## RESPONSE TO COMMENTS ON CRYSTAL RIVER UNIT 3 UPRATE PROJECT SITE CERTIFICATION APPLICATION

August 2007

**RESPONSE TO COMMENTS  
ON  
CRYSTAL RIVER UNIT #3 UPRATE PROJECT  
SITE CERTIFICATION APPLICATION**

**FIGURE 1**  
**Average Intake Monthly Temperatures**  
**(Pre and Post-Uprate Conditions)**

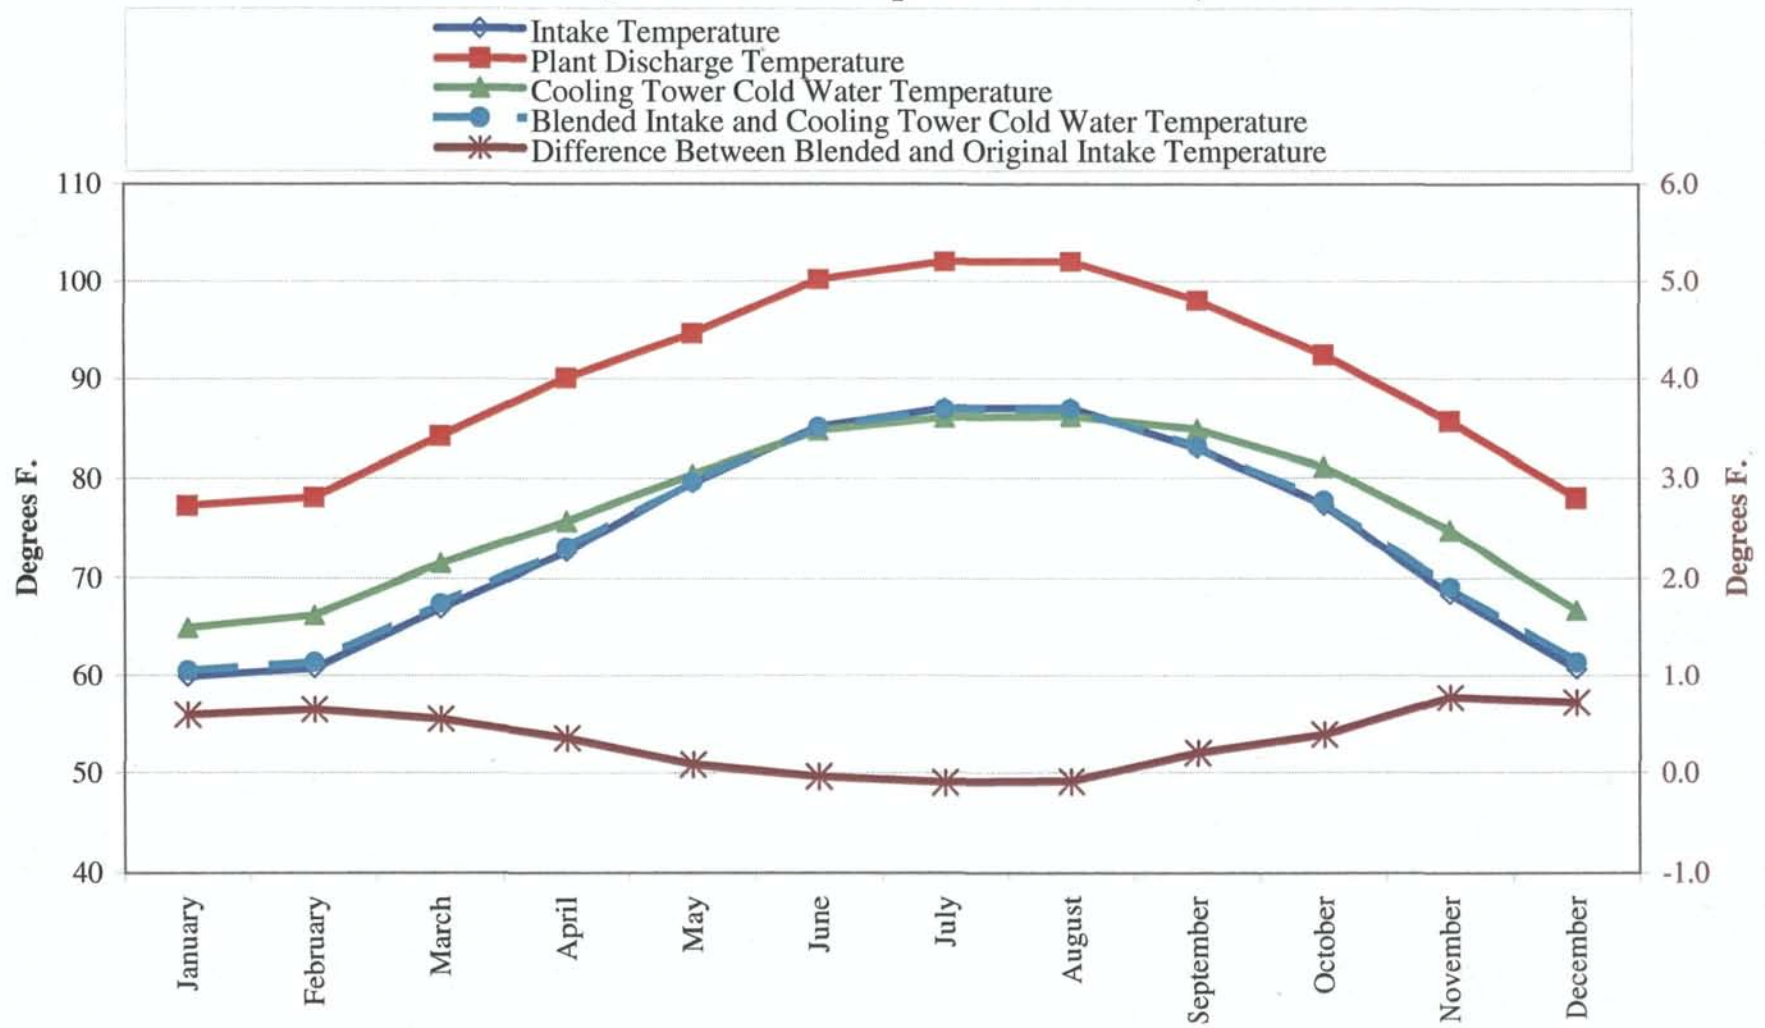
**12. The applicant has stated that there will be no net increase in thermal effluent into the Crystal Bay estuary. Please provide supporting information to substantiate this claim.**

shows the future SCT cold water temperature which will be recirculated to the intake canal, and the resulting blended temperature of the SCT's recirculating cells combined with the intake water. It shows that in no case does the SCT cooling tower discharge to the intake canal cause the three Units' intake temperature to increase by as much as one degree F. In fact, during summer months of July and August, the cooling tower cold water is predicted to actually reduce the Units' intake temperature slightly. Figure 1 displays the results of Table 1 graphically.

**FIGURE 7**  
**Pre-Uprate Circulating Water Flow Rates**

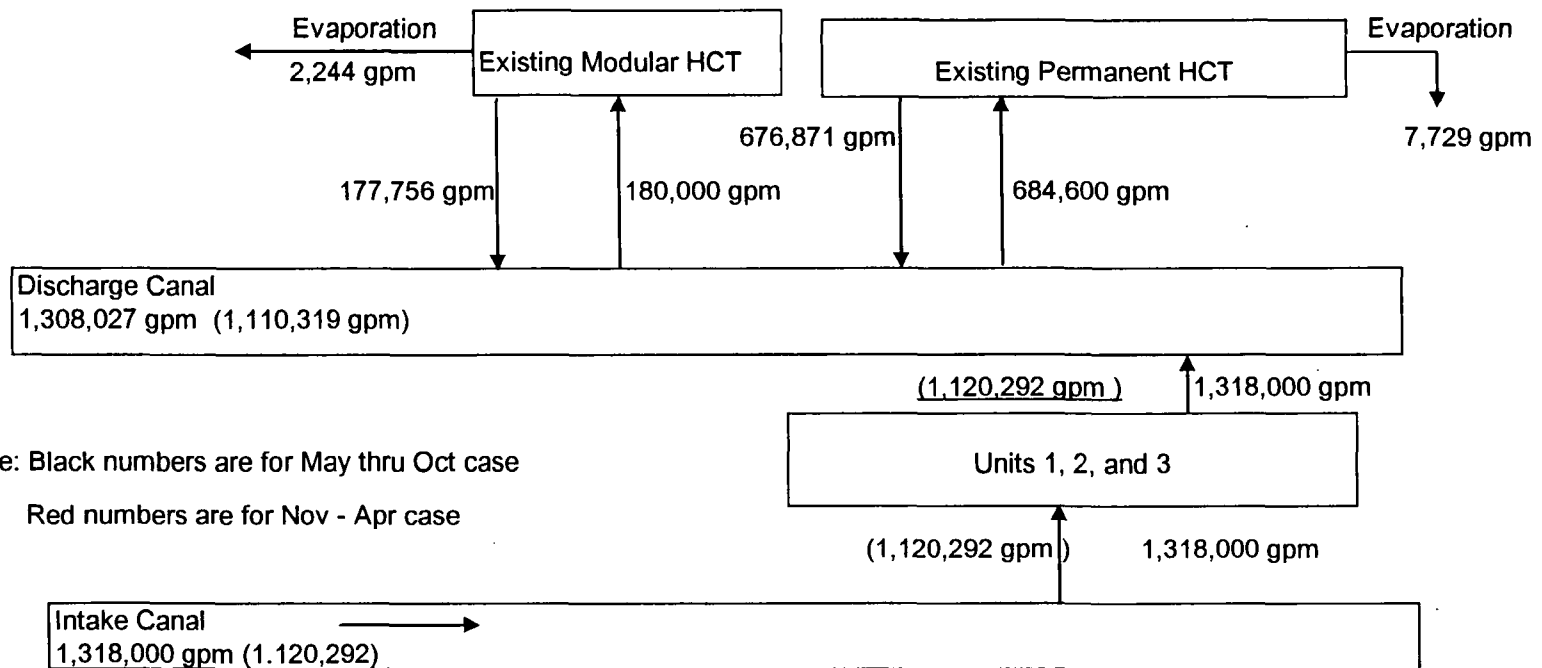
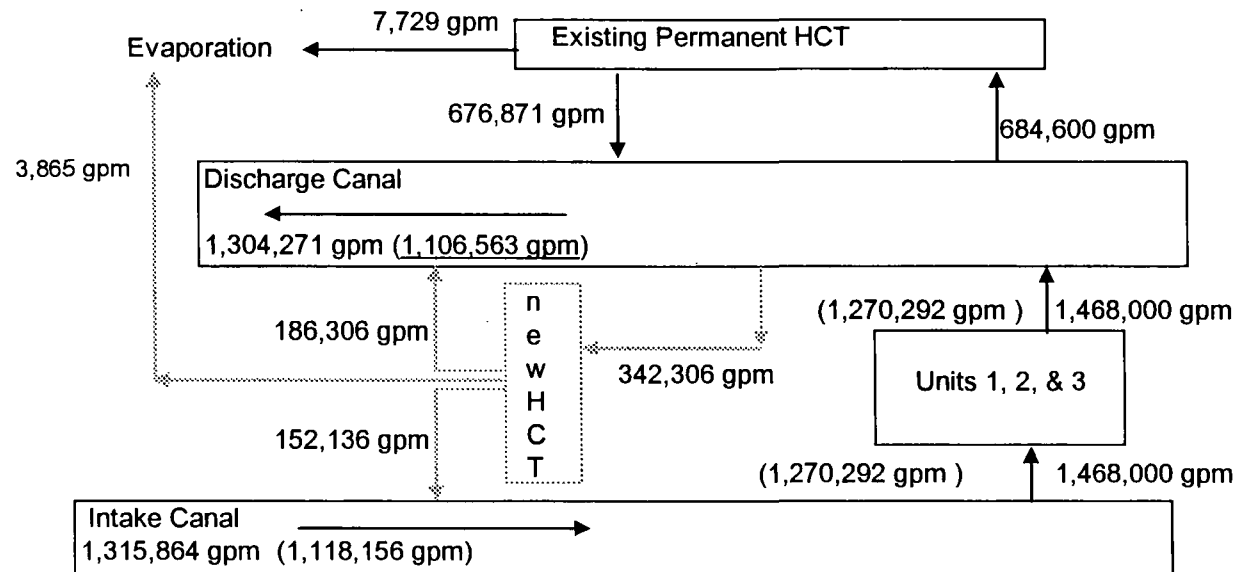
**11. Progress Energy has stated that the amount of water proposed to be withdrawn from Crystal Bay will be the same volume as currently utilized by the existing infrastructure. They have made assertion that there will be no increase of water withdrawn from Crystal Bay estuary due to facility upgrades and use of new improved technologies. Please provide supporting information to substantiate this claim.**

**Response:** Progress Energy has performed a preliminary analysis of the expected operating results from the proposed south Cooling Tower (SCT) described in Response FDEPSW-6 above.

Figure FDEPSW-11-1 (attached) shows the flow diagrams for the pre-uprate and post-uprate

cases. The existing NPDES permit limits the flow through the three units (1, 2, and 3) to 1,318,000 gpm (1,897.9 MGD) during the months May through October, and 1,132,792 gpm (1,613.2 MGD) during the months November through April. These are shown in the top diagram of Figure FDEPSW-11-1 labeled "Pre-Uprate". The existing flow from Crystal Bay to the plant is shown under the words "Intake Canal" as 1,318,000 gpm during May through October and 1,132,792 (in red) during November through April. The diagram assumes that the existing Helper Cooling Towers (HCT) are operating; however, the flow from Crystal Bay is the same whether the HCT operate or not.

The lower diagram in Figure FDEPSW-11-1 shows the estimated plant flow rates after the uprate is complete and the SCT is operational. This diagram assumes the largest potential increase in the circulating water flow rate of 150,000 gpm resulting in flow through the three units of 1,468,000 gpm during the months of May through October, and 1,270,292 gpm during the months of November through April. The conceptual design of the SCT requires that the southernmost 8 cells operate year-round in the recirculating mode, whenever all three units are operating, in order to avoid any increase in discharge temperature or heat rejected to Crystal Bay, and to avoid any increase in flow withdrawn from Crystal Bay. In the Post-Uprate diagram shown in Figure FDEPSW-11-1, it has been assumed that the remaining 10 cells will be operating in the helper cooling tower mode in order to continue to meet the NPDES limits on rolling average discharge canal exit temperature. The 152,136 gpm that is recirculated from the new SCT 1 will be discharged to the intake canal via a diffuser to ensure that it is well-mixed with the incoming flow from Crystal Bay. As shown on the diagram, this recirculation of 152,136 gpm will reduce the amount of water withdrawn from Crystal Bay to 1,315,864 gpm during May through October, and to 1,118,156 gpm during November through April. Both of these withdrawals are reduced from the pre-uprate case and comply with the existing permit limits.

PROJECT NO. GOLAS00-07199  
PROJECT: Progress Energy Uprate  
TITLE: 2009 Build Traffic Volumes

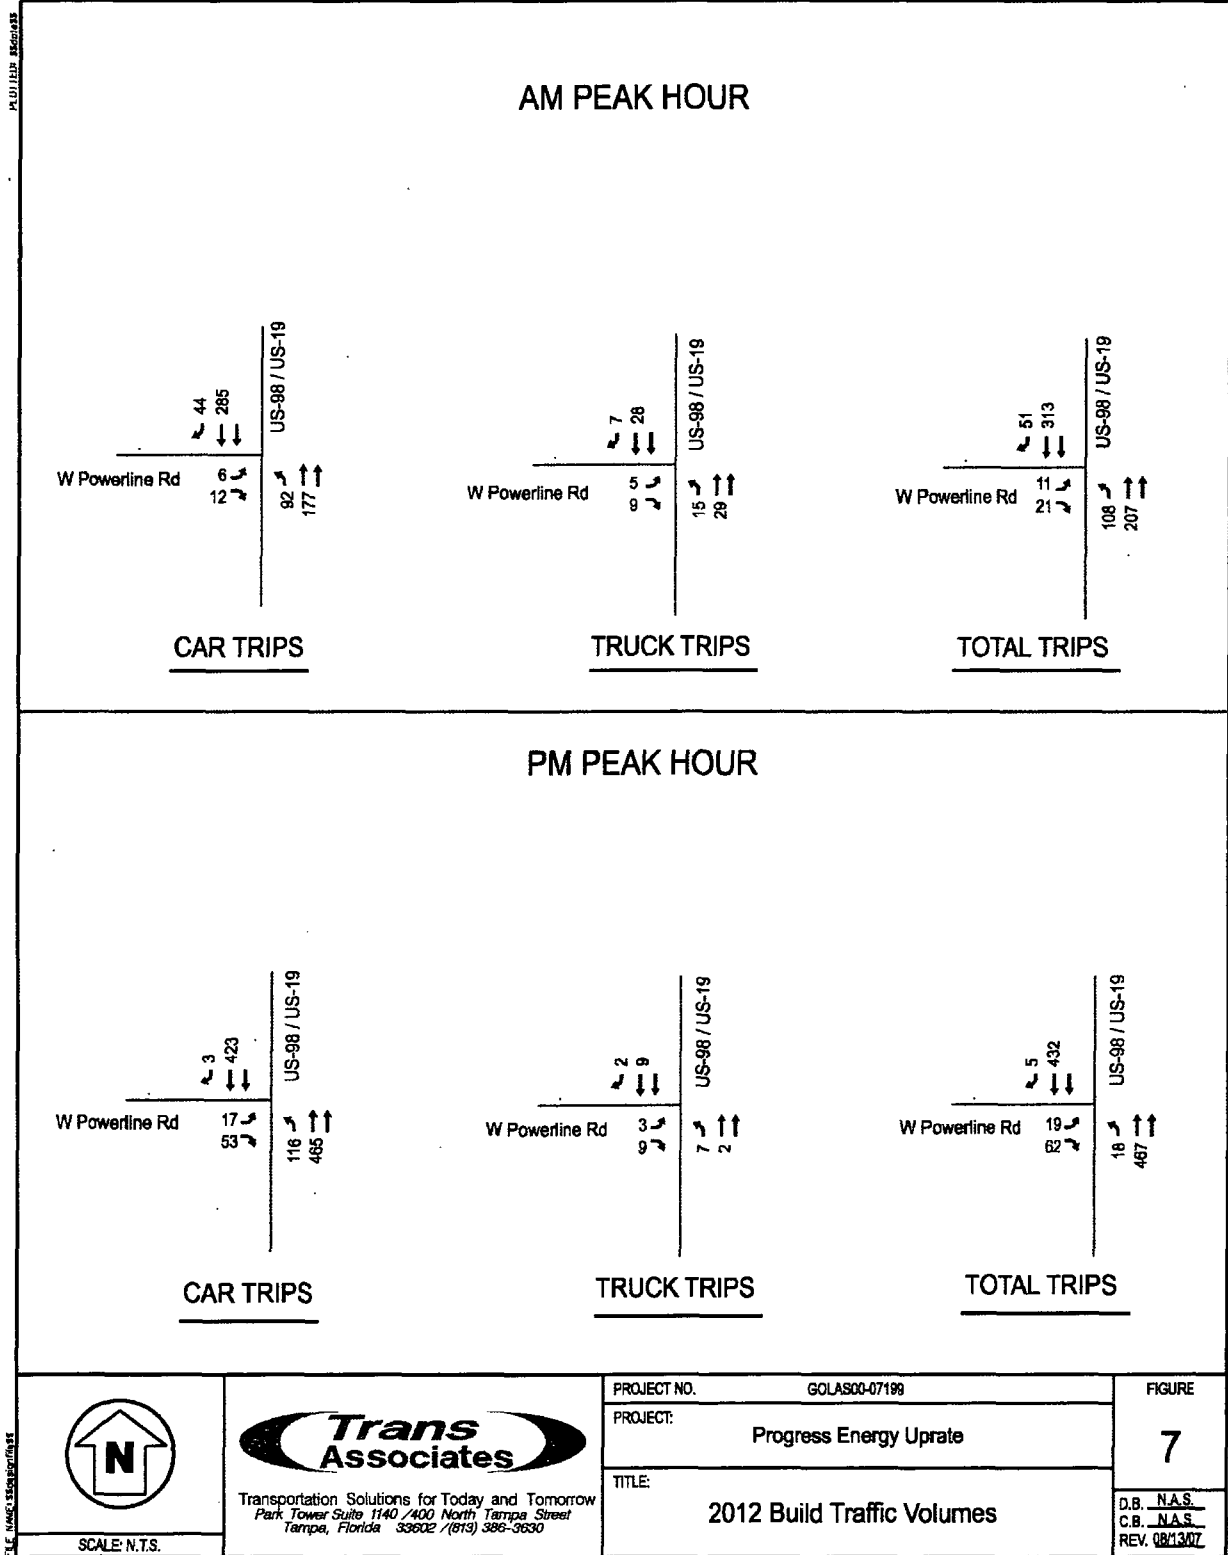
**4b. There are discrepancies in the volume data which need to be clarified. For example, Table 4.6.2-1 indicates that peak hour project volume on U.S. 19 will be 655; however, Figure 4.6.2-1 indicates there will be 966 northbound left turns and another 461 southbound right turns at the intersection of Power Line Road and U.S. 19.**

The volume of 966 northbound left turns and 461 southbound right turns from Figure 6 reflect a 2009 temporary, total traffic condition.
